| PROJECT NOS. BRF 0162(16), (17), (18) | CONTRACTOR: W.M. SCHULTZ CONSTRUCTION, INC. | | |
| BRIDGE NOS. 15, 16 & 19 | | | |

BEARING ASSY FOR:
STATE OF VERMONT AGENCY OF TRANSPORTATION

VT ROUTE 73 (RURAL MAJOR COLLECTOR)

MK.01
LAMINATED BEARING PADS
 (16) @ BRIDGE 15, BRF 0162(16)
 (12) @ BRIDGE 16, BRF 0162(17)
(28) REQ'D

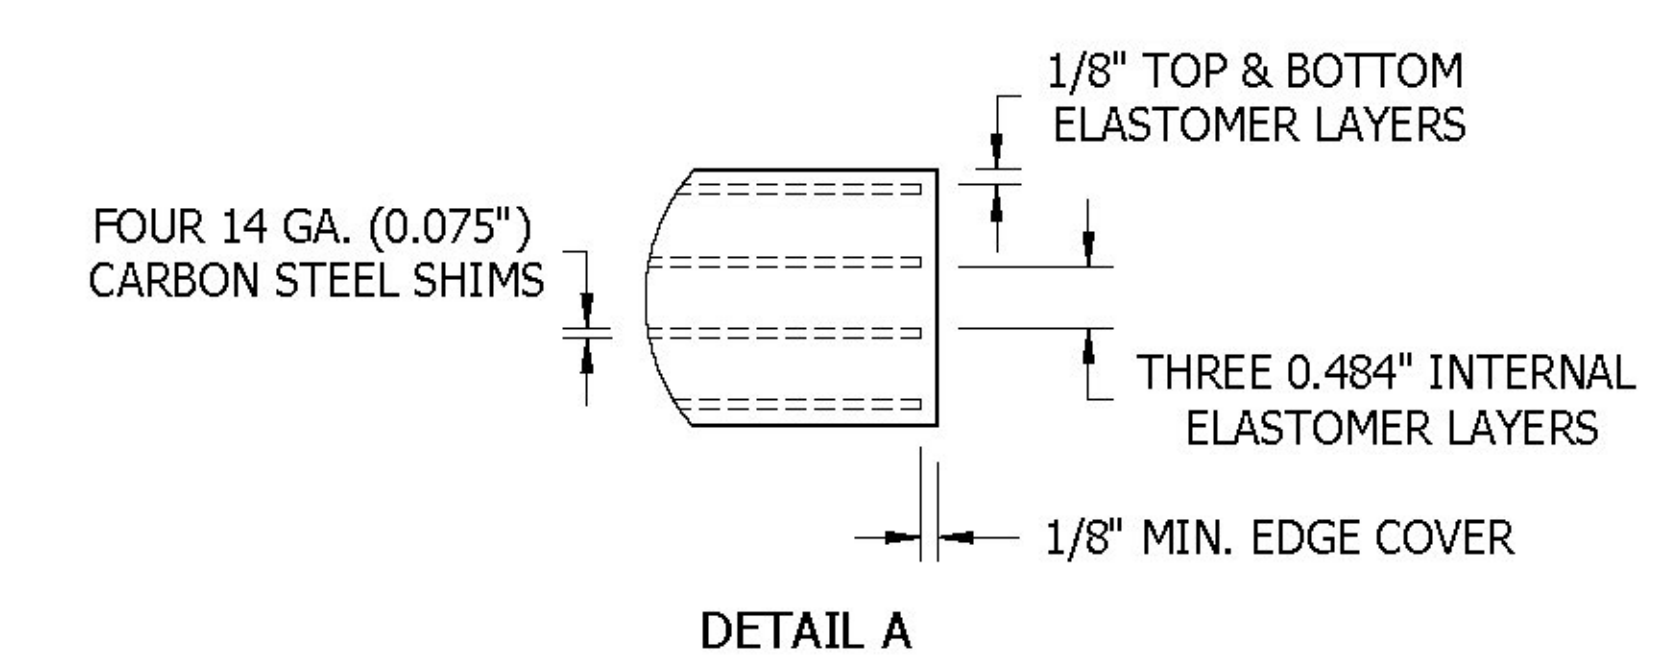
CARBON STEEL SHIMS.....ASTM A1011, GR. 40
 (QUOTED 14 GA. IN LIEU OF 1/16" DUE TO AVAILABILITY)
